FINAL DRAINAGE LETTER AND PLAN

EQUIPMENT RESOURCES 7340 UTAH LANE EL PASO COUNTY, COLORADO

JANUARY, 2019

Storm Sewer Profile

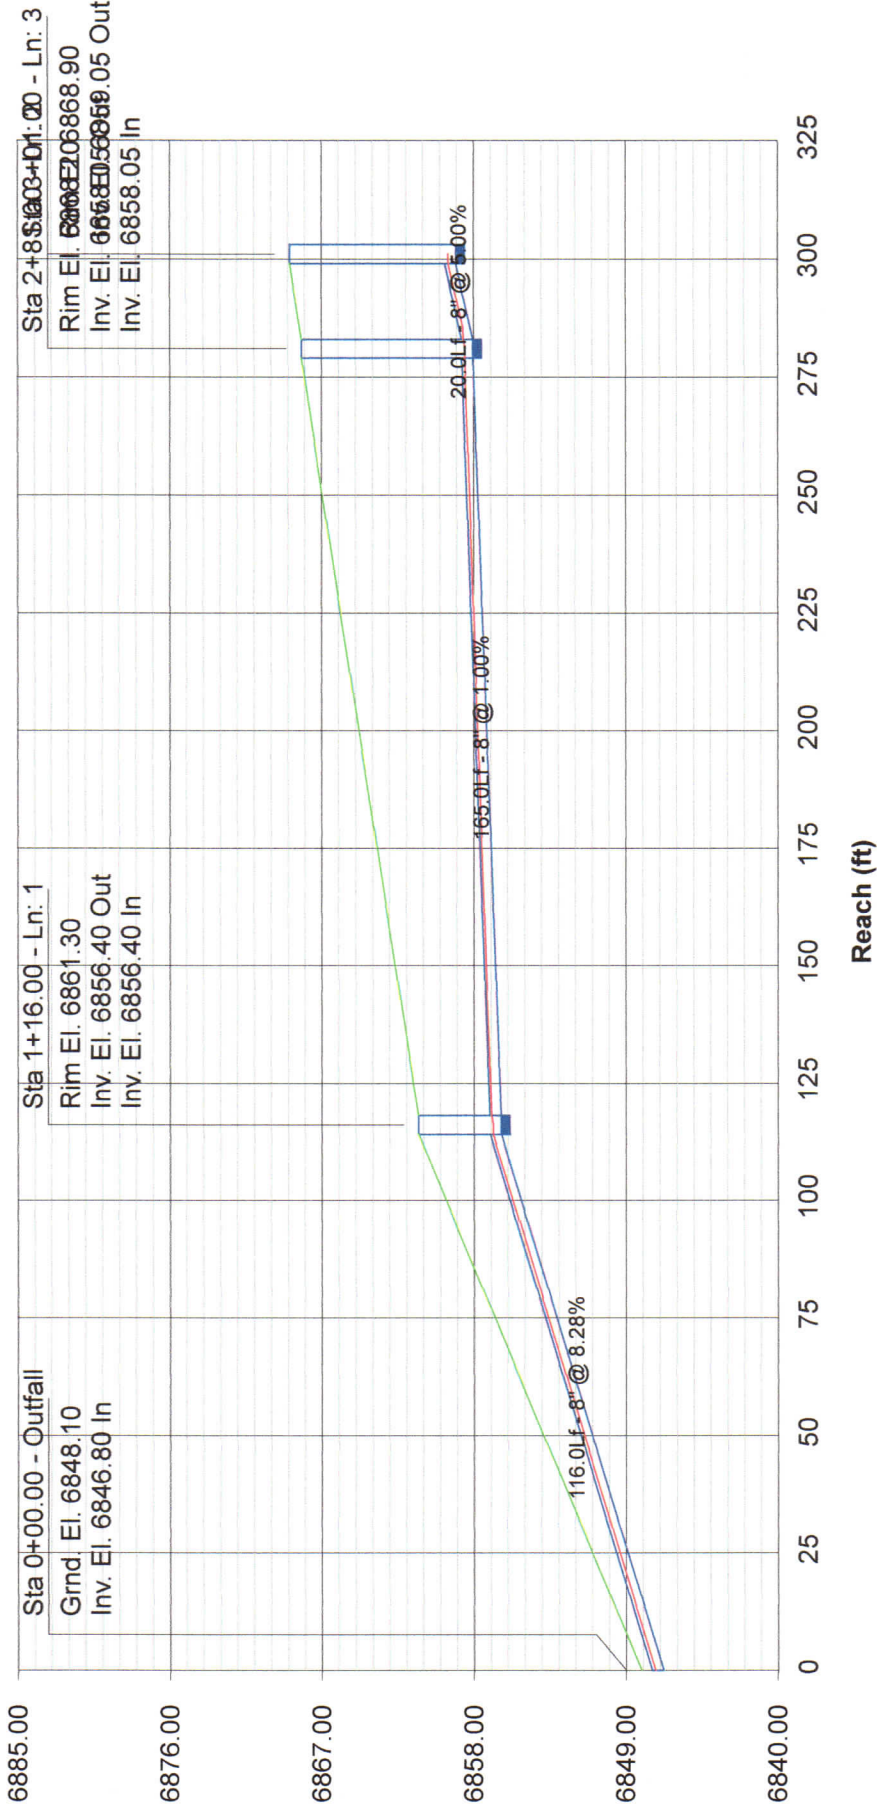
Provide a legend for the line types

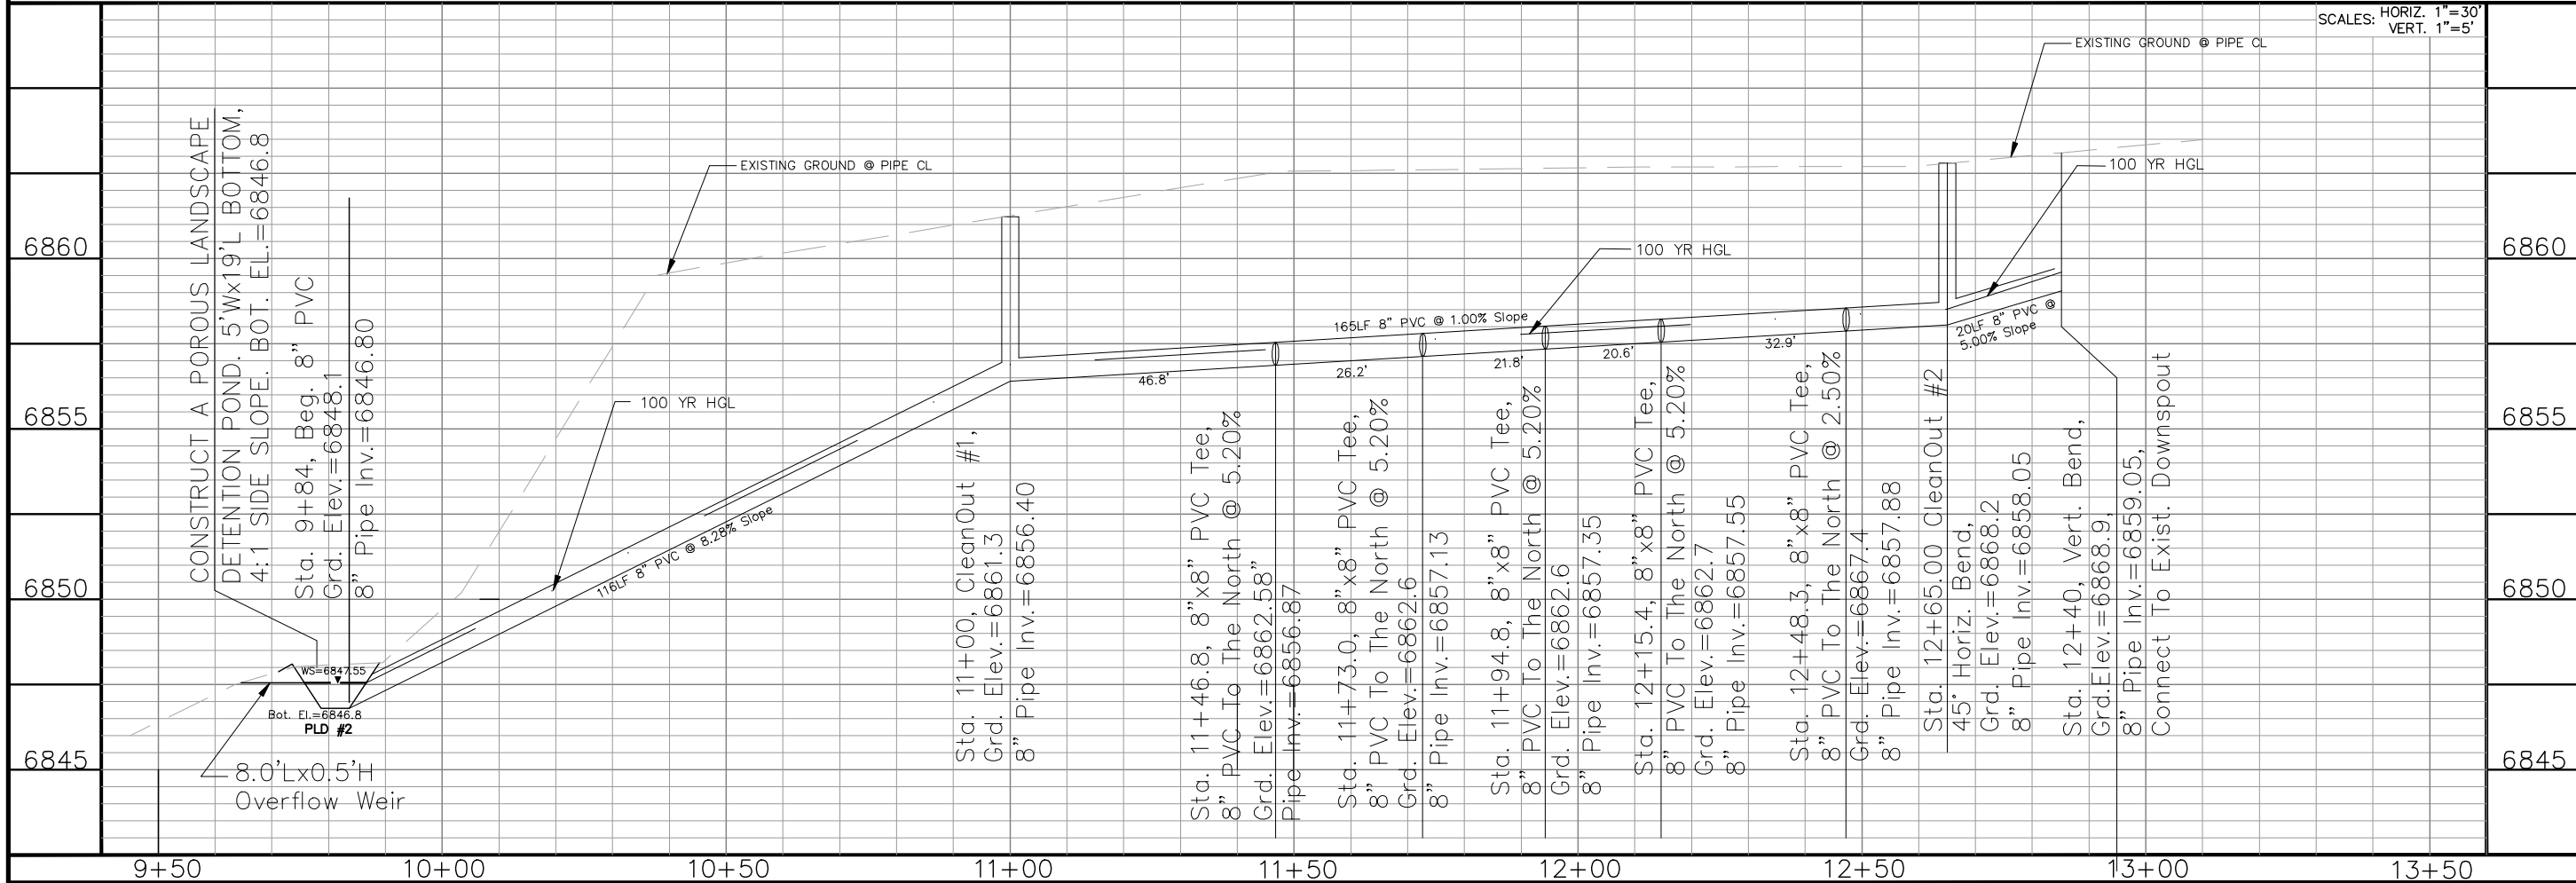
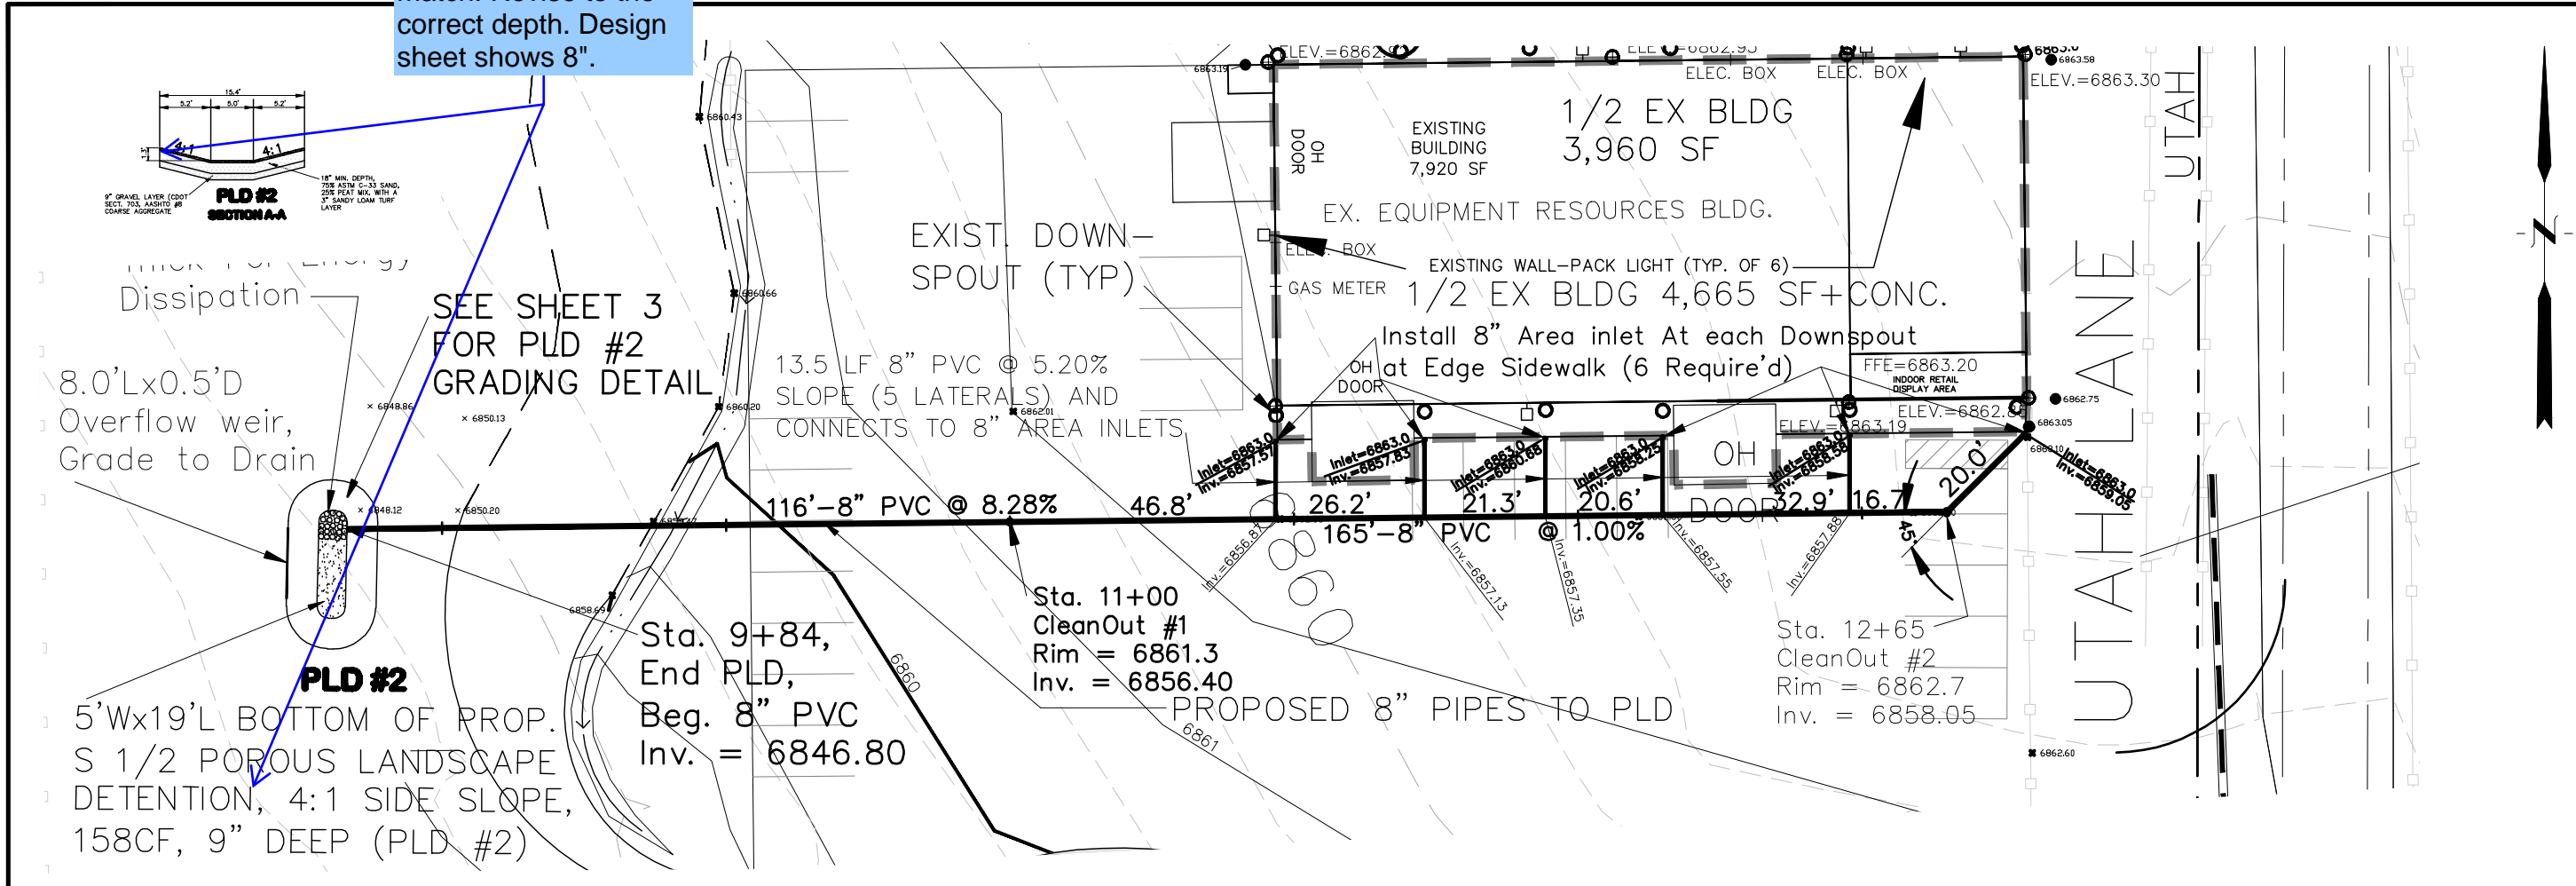
These depths do not match. Revise to the correct depth. Design sheet shows 8".

**POROUS LANDSCAPE DETENTION GRADING
7340 UTAH LANE
EL PASO COUNTY, COLORADO**

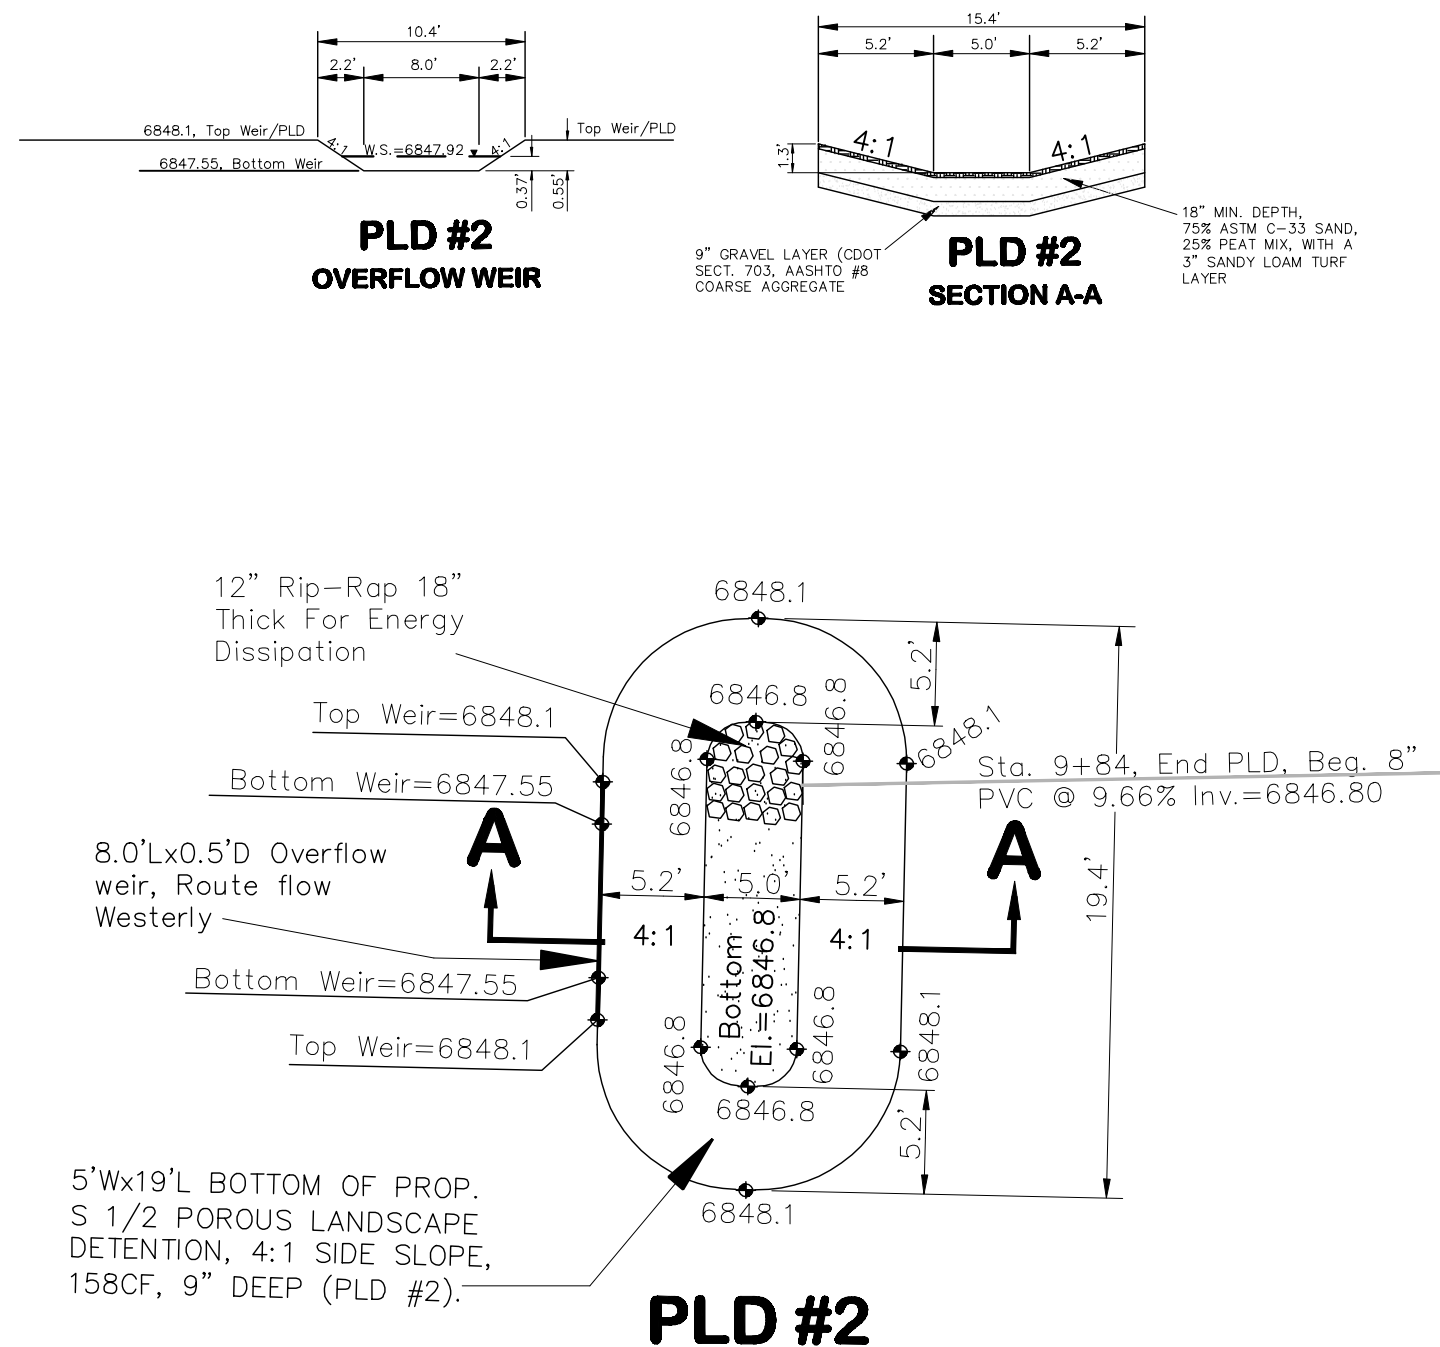
These construction details should must be in the construction drawings, not in the drainage report.
